AMMENDMENT TO WESTOVER VALLEY SUBDIVISION (UNITS 1 & 2) MASTER DEVELOPMENT PLAN

Re: Westover Valley Subdivision (Amendment)

MDP # 762A

The City Staff Development Review Committee has reviewed Westover Village Master Development Plan (Amendment) M.D.P. # 762A. Please find enclosed a signed copy for your files. Your plan was accepted, however please note the following:

TYPICAL STREET SECTIONS (50' R.O.W.)
(LOCAL TYPE "A")
N.T.S.TYPICAL STREET SECTION (70' R.O.W.)
(COLLECTOR STREET-IMPALA SUMMIT)
N.T.S.

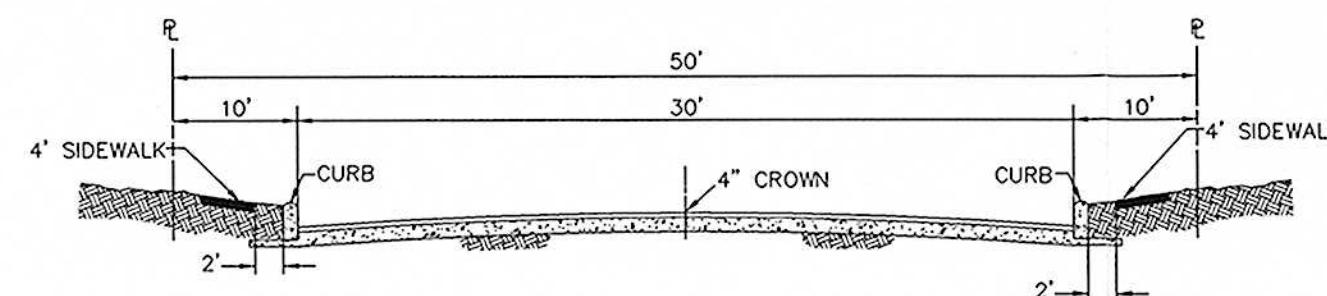
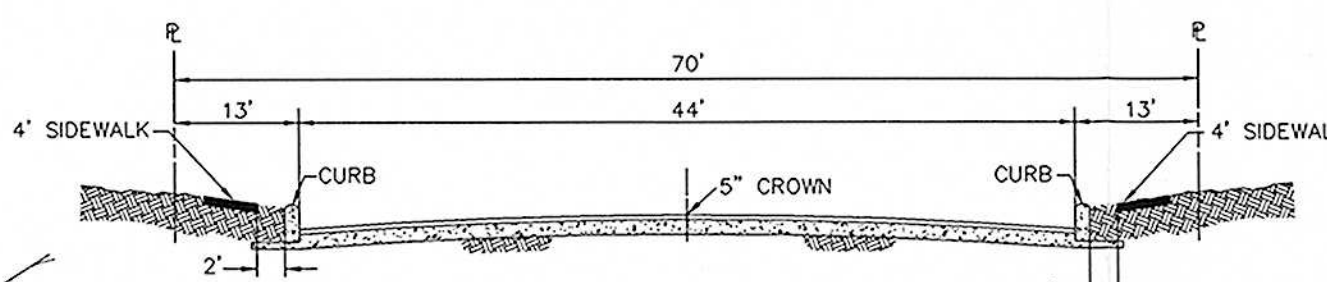
1. The existing median opening on eastbound Wiseman Blvd. shall be modified to provide a minimum of 153 feet of storage capacity.
 2. The proposed collector will have a minimum of 70 ft. ROW with 44 ft. pavement and shall be extended from Wiseman Blvd to the northern portion of Unit One.
